ADDENDUM NO. 1

TO: PLANS AND SPECIFICATIONS FOR STATE OF MISSOURI

Renovate Interior & Exterior Readiness Center Building
Mexico Readiness Center
Mexico, Missouri
PROJECT NO.: T2318-01

02 CANOPY DETAIL SECTION

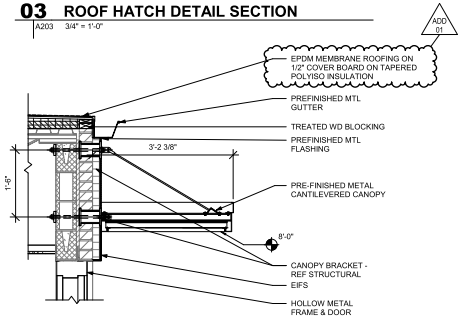
b. Drawing 02 CANOPY DETAIL SECTION:
   i. REMOVE and REPLACE the following: EPDM MEMBRANE ROOFING ON ½” GYPSUM SHEATHING COVER BOARD ON TAPERED POLLYISO INSULATION ON VAPR BARRIER to EPDM MEMBRANE ROOFING ON ½” COVER BOARD ON TAPERED POLYISO INSULATION.

01 ROOF PLAN - NEW WORK

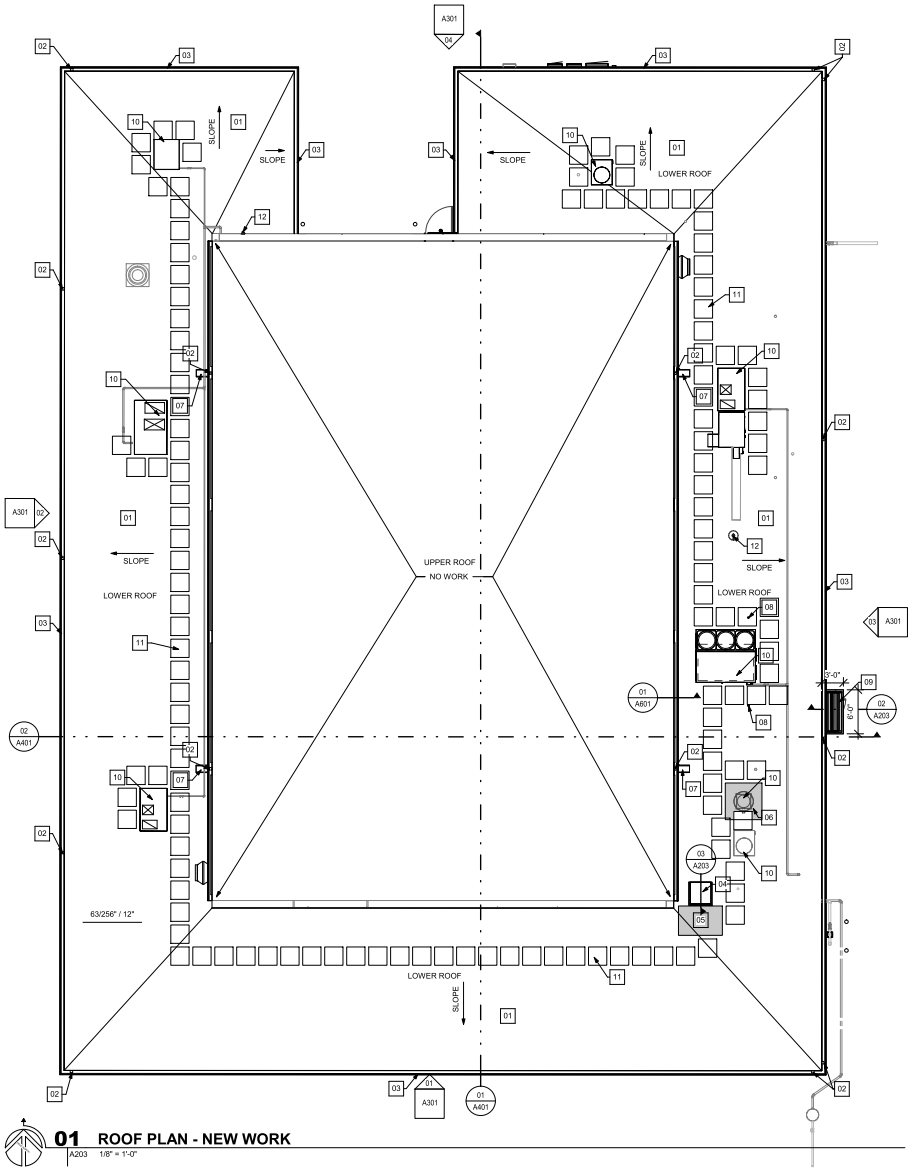
3. Sheet A203 MRC BUILDING ROOF PLAN:
   a. KEYNOTES – ROOF PLAN:

i. Note 01: REMOVE “ON VAPOR BARRIER” from note. Vapor Barrier is not required with the roof system.

02 TYP. CLERESTORY SILL DETAIL

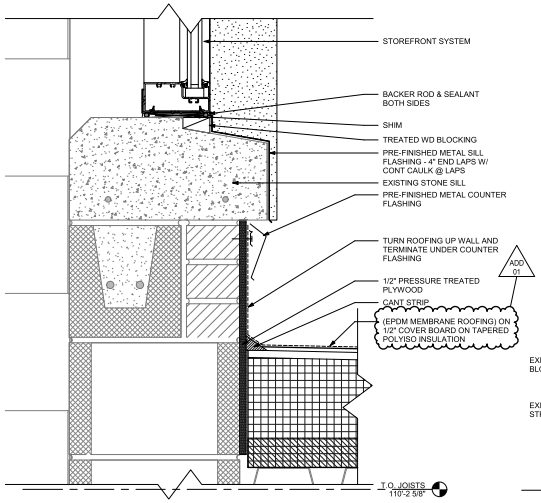
b. Drawing 02 TYP. CLERESTORY SILL DETAIL
      i. REMOVE “ON VAPOR BARRIER” from notes. Vapor Barrier is not required with the roof system.

01 TYP. CLERESTORY WALL SECTION

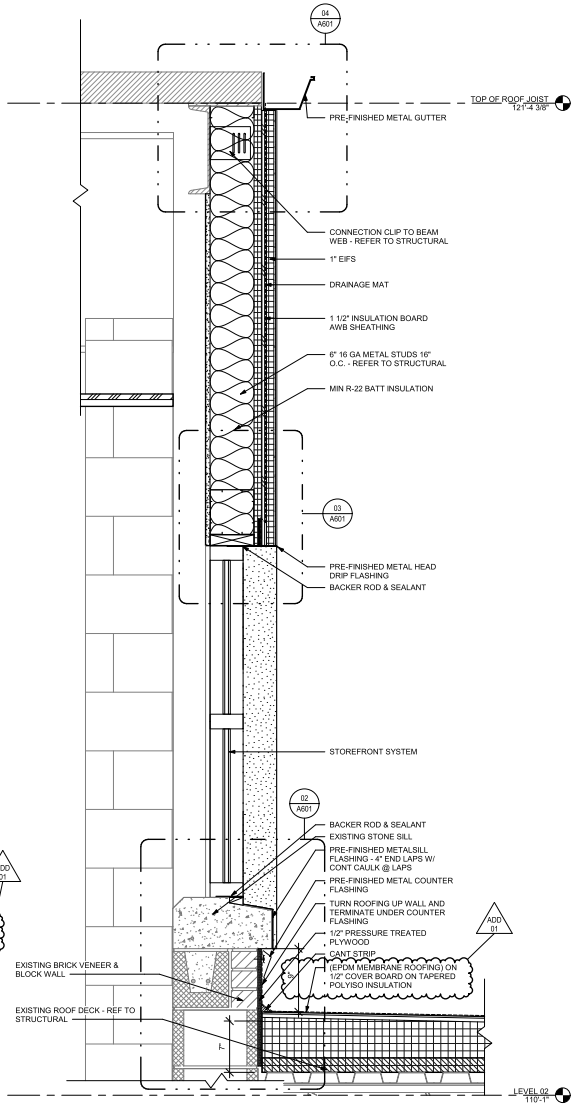
4. Sheet A601 WALL SECTIONS
   a. Drawing 01 TYP. CLERESTORY WALL SECTION
      i. REMOVE “ON VAPOR BARRIER” from notes. Vapor Barrier is not required with the roof system.

02 COLD STORAGE - DEMOLITION PLAN

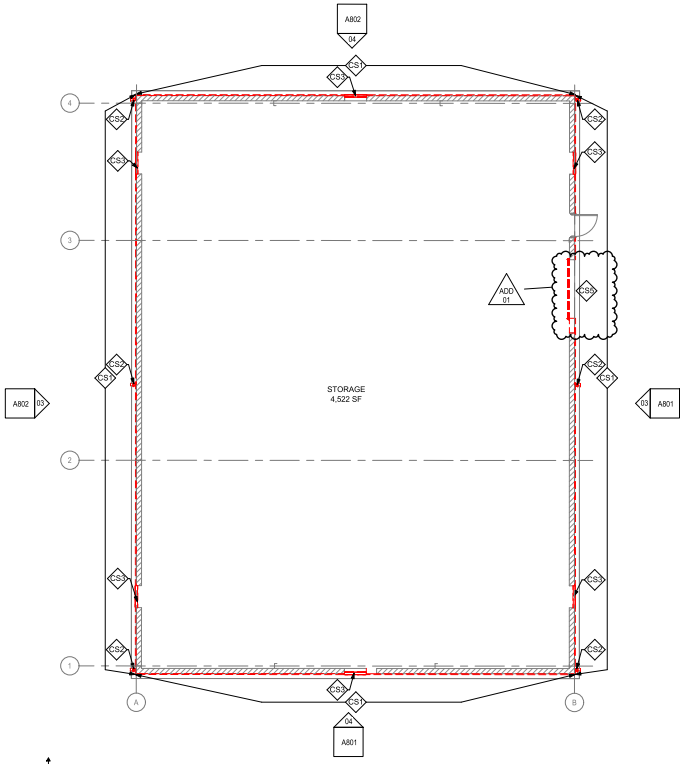
6. Sheet A801 ALT. NO. 2 – COLD STORAGE BUIDLING DEMOLITION & NEW WORK PLANS
   a. KEYNOTES – COLD STORAGE DEMOLTION PLAN
      i. ADD note “CS5 OVERHEAD DOOR – REMOVE”

b. Drawing 02 COLD STORAGE – DEMOLTION PLAN
      i. ADD keynote “CS5” with leader pointing to overhead door to be removed.

CS1	PREFINISHED METAL WALL PANELS & BASE ANGEL - REMOVE
CS2	PREFINISHED METAL DOWNSPOUT - REMOVE
CS3	PREFINISHED METAL LOUVER & SCREEN - REMOVE & SALVAGE FOR REINSTALLATION
CS4	PREFINISHED METAL GUTTER - REMOVE & SALVAGE FOR REINSTALLATION
CS5	OVERHEAD DOOR - REMOVE

02 OLD FMS - DEMOLITION PLAN
A803 1/8" = 1'-0"

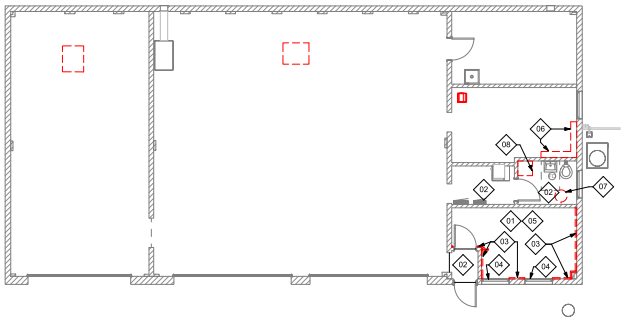
7. Sheet A803 ALT. NO. 3 – OLD FMS – DEMOLITION, NEW WORK & REFLECTED CEILING PLANS
   a. KEYNOTES – OLD FMS DEMOLITION PLAN
      i. Note 3: REPLACE “WOOD WALL PANELING – REMOVE” with “WOOD WALL PANELING, FURRING STRIPS & ADHESIVE – REMOVE AND PROPERLY PREPARE WALL FOR NEW FINISH”

01	CARPET AND BASE - REMOVE
02	VCT AND BASE - REMOVE
03	WOOD WALL PANELING, FURRING STRIPS & ADHESIVE - REMOVE AND PROPERLY PREPARE WALL FOR NEW FINISH
04	WINDOW SHADES - REMOVE
05	ACOUSTIC CEILING TILE - REMOVE
06	REMOVE & SALVAGE BUILT-IN ELEMENT
07	WATER HEATER - REFER TO PLUMBING
08	WOOD PLATFORM - REMOVE

1 HVAC PLAN MAIN BUILDING DEMO

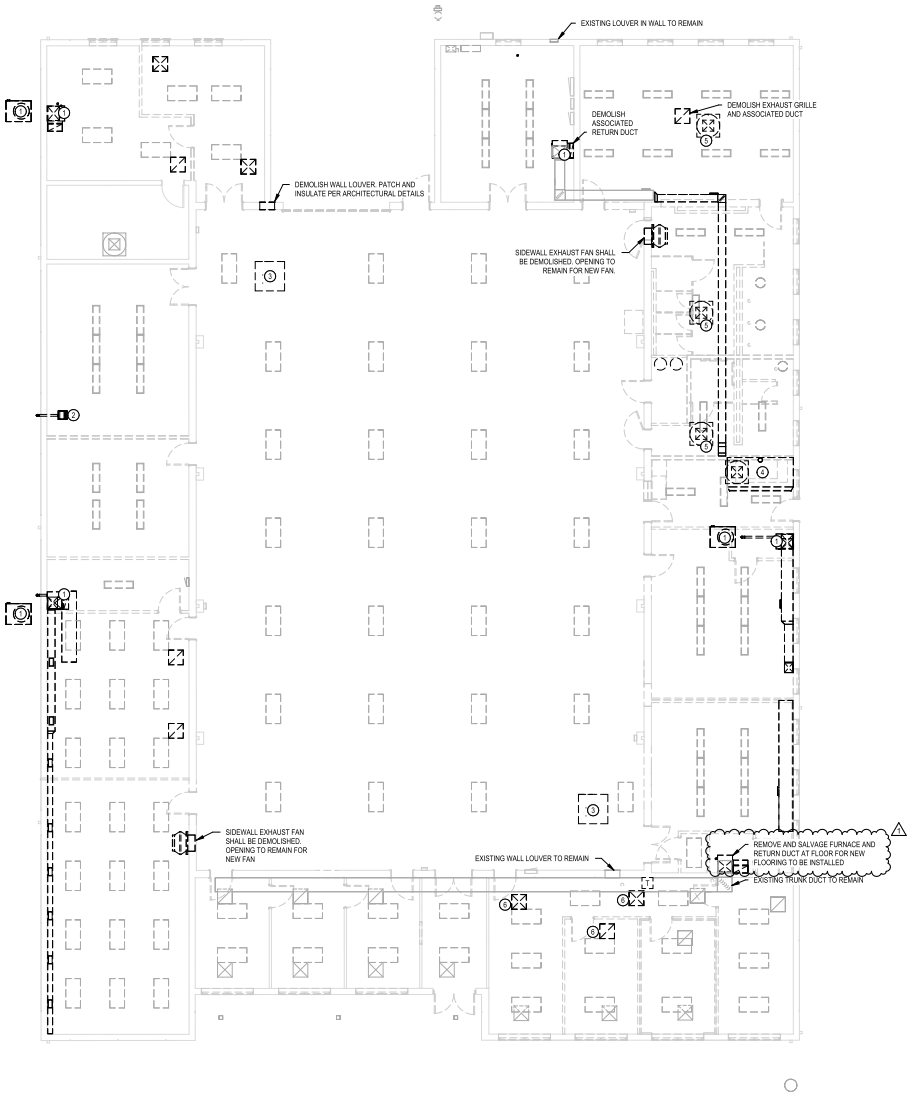
8. Sheet MD101 MAIN BUILDING MECHANICAL DEMO PLAN
    a. Drawing 1 HVAC PLAN MAIN BUILDING DEMO
        i. In MECH/ELEC 122 ADD note “REMOVE AND SALVAGE FURNACE AND RETURN DUCT AT FLOOR FOR NEW FLOORING TO BE INSTALLED” and REVISE drawing to indicate removal of furnace and ductwork.

1 HVAC PLAN MAIN BUILDING

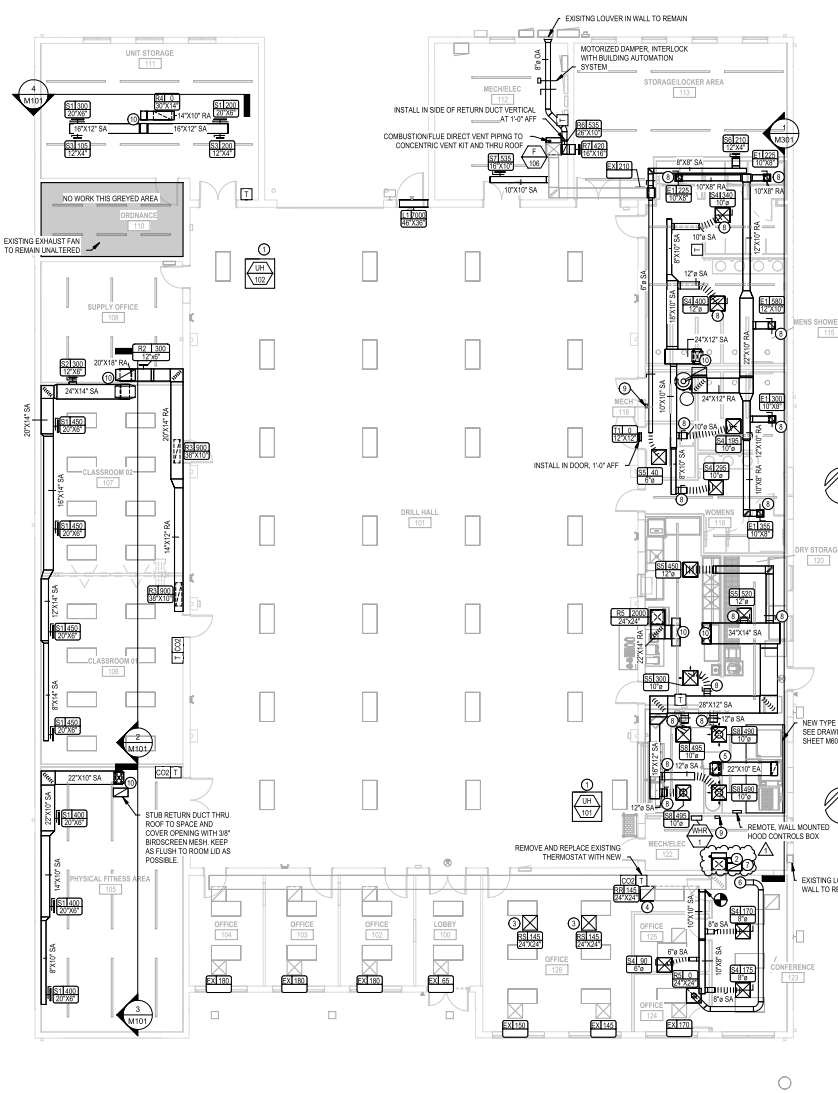
9. Sheet M101 MAIN BUILDING MECHANICAL PLAN
    a. MECHANICAL KEYNOTES: REPLACE note 2 “EXISTING FURNACE TO REMAIN” with note “REINSTALL SALVAGED FURNACE AND DUCTWORK IN SAME LOCATION AFTER NEW FLOORING IS INSTALLED. RECONNECT INTO EXISTING SUPPLY AND RETURN DUCT.”

b. Drawing 1 HVAC PLAN MAIN BUILDING
        i. In MECH/ELEC ADD note “EXISTING FURNACE TO REMAIN” with note “REINSTALL SALVAGED FURNACE AND DUCTWORK IN SAME LOCATION AFTER NEW FLOORING IS INSTALLED. RECONNECT INTO EXISTING SUPPPLY AND RETURN DUCT.” AND REVISE DRAWING TO INDICATE REINSTALLATION OF FURNACE AND RETURN DUCT.
        ii. REVISE drawing to indicate demolition of furnace.

1	1	INSTALL NEW UNIT HEATER AT LOCATION OF DEMOLISHED HEATER.
2	2	REINSTALL SALVAGED PURIANCE AND DUCTWORK IN SAME LOCATION AFTER NEW FLOORING IS INSTALLED. RECONNECT INTO EXISTING SUPPLY AND RETURN DUCT.
	3	RELOCATE EXISTING SUPPLY DIFFUSER AS SHOWN. EXTEND MIN. 6" DUCTWORK FROM EXISTING LOCATION AS REQUIRED. IF EXISTING IS FOUND TO BE LESS THAN 8", REPLACE WITH NEW 8" AND MANUAL DAMPER FROM MAIN SUPPLY TRUNK.
	4	RELOCATE EXISTING RETURN GRILLE AS SHOWN.
	5	GREASE EXHAUST DUCT UP TO GREASE EXHAUST FAN ON ROOF. SEE DETAIL SHEET M502.
	6	TIE INTO EXISTING MAIN TRUNK RETURN DUCT THIS APPROXIMATE LOCATION. CONTRACTOR SHALL FIELD VERIFY EXACT LOCATION OF DUCT TO TIE INTO.
	7	INSTALL NEW MOTORIZED DAMPER AND MANUAL DAMPER IN EXISTING 12X12 OUTSIDE AIR DUCT. BALANCE PER SPLIT SYSTEM EQUIPMENT SCHEDULE.
	8	ELECTRO-BALANCE #EB-250 ROUND DAMPER SYSTEM FOR REMOTE DAMPERS. SINGLE BLADE BALANCING DAMPER EQUAL TO MAT #EB-250 WITH UNIVERSAL DAMPER DRIVE #EB-UDD FACTORY MOUNTED TO DAMPER. DAMPER DRIVE SHALL BE WIRED TO CONNECTOR WALL PLATE LOCATED IN STORAGE ROOM (SEE KEY NOTE 9). SYSTEM SHALL BE ORDERED AS A COMPLETE DAMPER SYSTEM WITH ALL NECESSARY COMPONENTS FOR APERATION. SEE DETAIL SHEET M501.

1 ELECTRICAL PLAN MAIN BUILDING DEMO
ED101 1/8" = 1'-0"

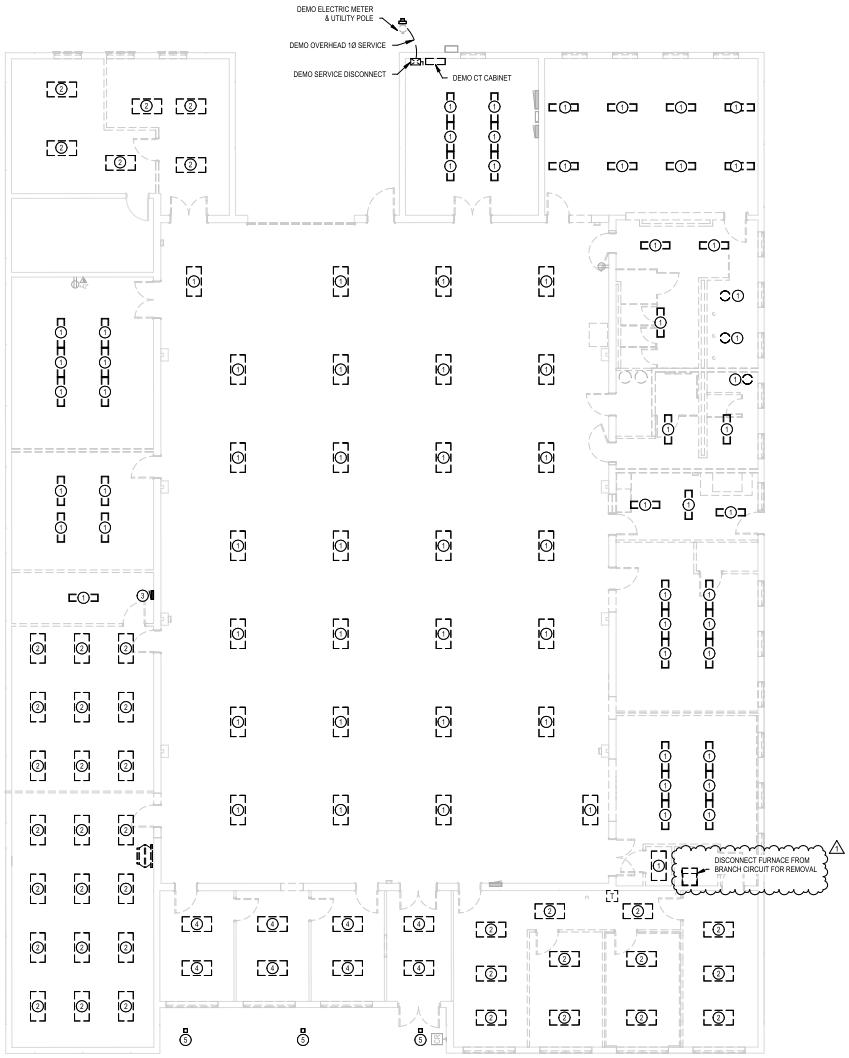
10. Sheet ED101 ELECTRICAL DEMO PLAN
    a. Drawing 1 ELECTRICAL PLAN MAIN BUILDING DEMO
        i. In MECH/ELEC 122 ADD note “DISCONNECT FURNACE FROM BRANCH CIRCUIT FOR REMOVAL”
        ii. REVISE drawing to indicate disconnection of furnace.

2 POWER PLAN ENLARGED KITCHEN

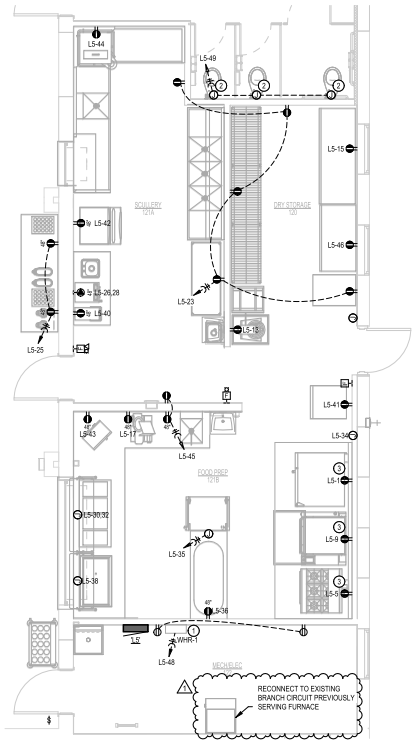
11. Sheet EP101 MAIN BUILDING ELECTRICAL POWER PLAN
    a. Drawing 2 POWER PLAN ENLARGED KITCHEN
        i. In MECH/ELEC 122 ADD note “RECONNECT TO EXISTING BRANCH CIRCUIT PREVIOUSLY SERVING FURNACE”

1 PLUMBING PLAN MAIN BUILDING DEMO

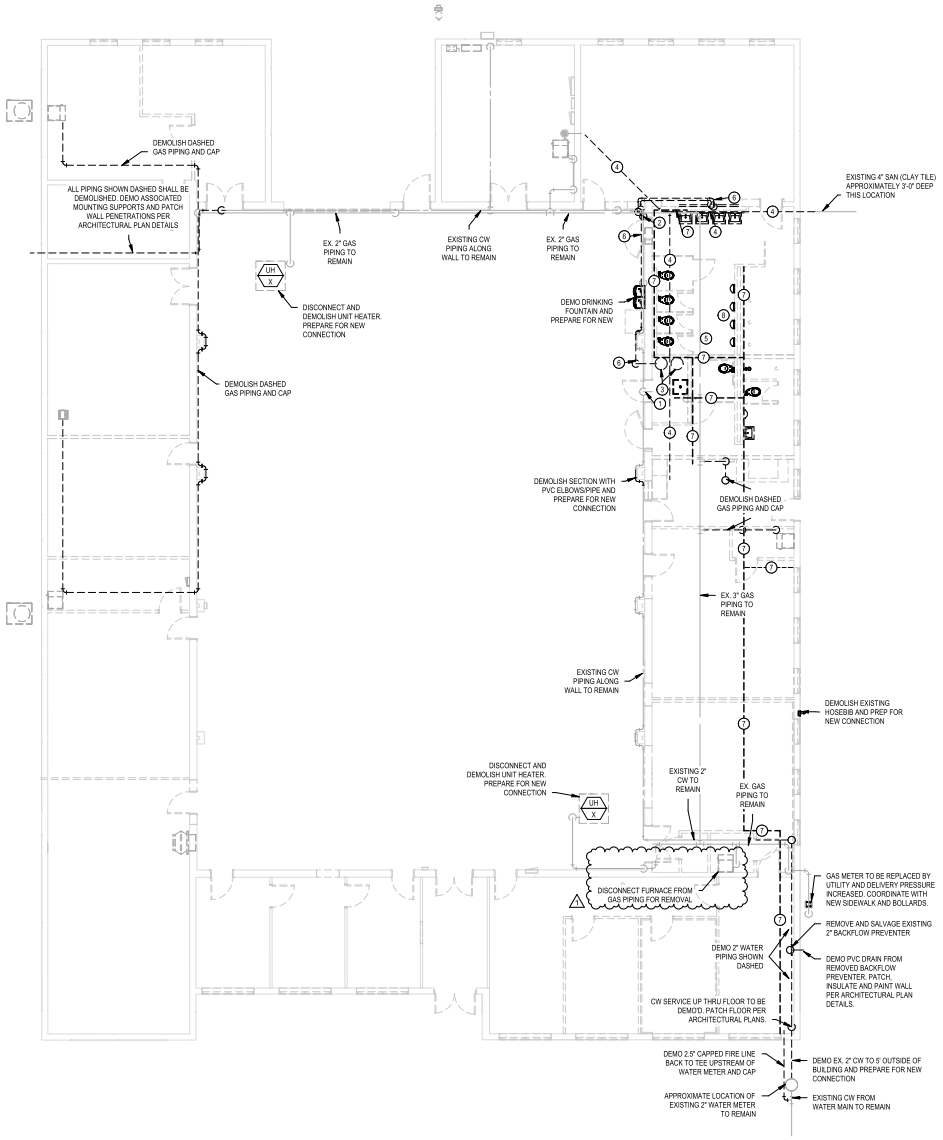
12. Sheet PD101 MAIN BUILDING PLUMBING DEMO PLAN
    a. Drawing 1 PLUMBING PLAN MAIN BUILDING DEMO
        i. In MECH/ELEC ADD note “DISCONNECT FURNACE FROM GAS PIPING FOR REMOVAL” and REVISE drawing to indicate demolition of furnace.

1 PLUMBING PLAN ELARGED - WATER AND GAS
P401 3/16" = 1'-0"

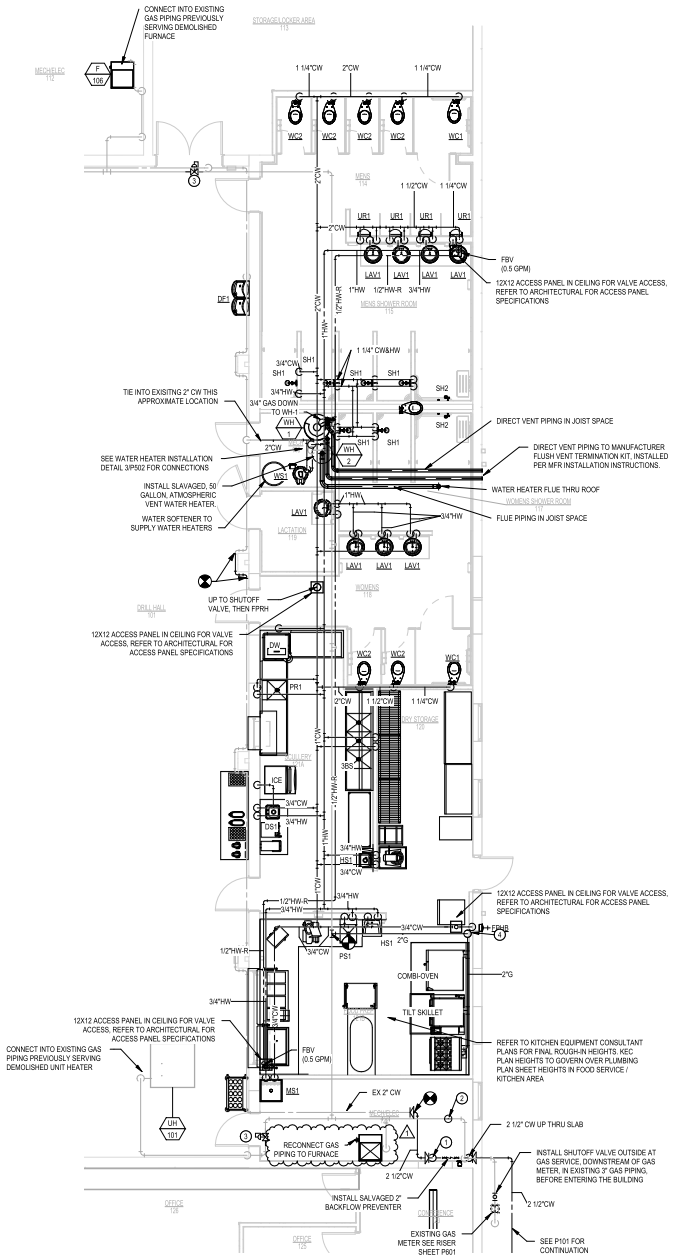
13. Sheet P401 MAIN BUILDING PLUMBING PLANS ENLARGED
    a. Drawing 1 PLUMBING PLAN ENLARGED – WATER AND GAS
        i. In MECH/ELEC 122 ADD note “RECONNECT GAS PIPING TO FURNACE”

01 MRC - FOODSERVICE EQUIPMENT FLOOR PLAN
Q-FP-01 1/4" = 1'-0"

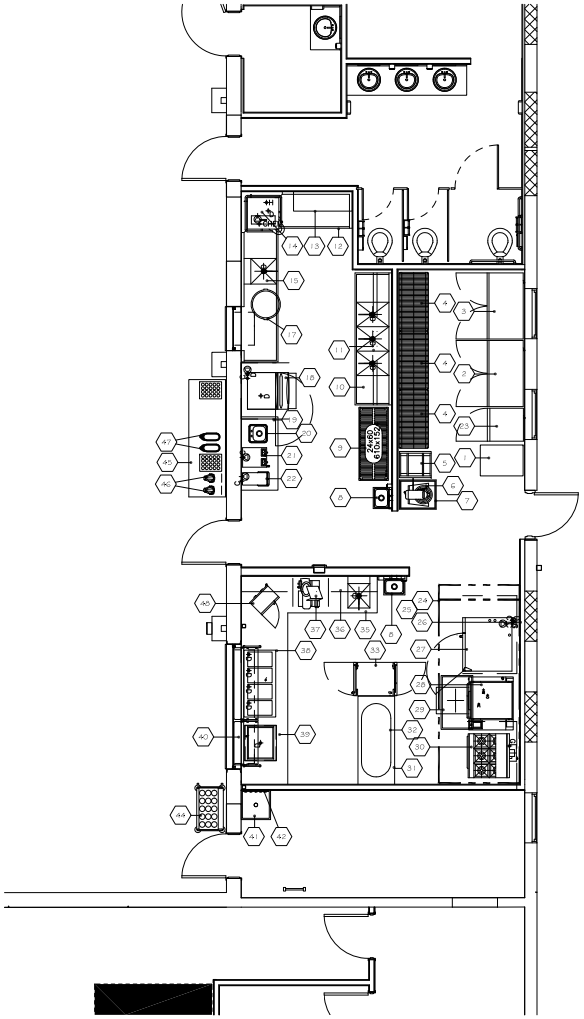
14. Sheet Q-FP-01 FOODSERVICE EQUIPMENT FLOOR PLAN
    a. EQUIPMENT SCHEDULE - LOG CLASSIFICATION
        i. REVISE note “B.” to be note “C.”

C: PORTABLE EQUIPMENT WHICH WILL BE PROVIDED THROUGH SUPPLY CHANNELS AND OWNER INSTALLED (AND WHICH SHOULD NOT BE IN THE CONSTRUCTION CONTRACT) AND FOR WHICH NO UTILITY HOOK-UPS ARE REQUIRED (BUT WHICH SHOULD BE CONSIDERED IN THE SPACE LAYOUT AND OPERATIONAL PLAN)
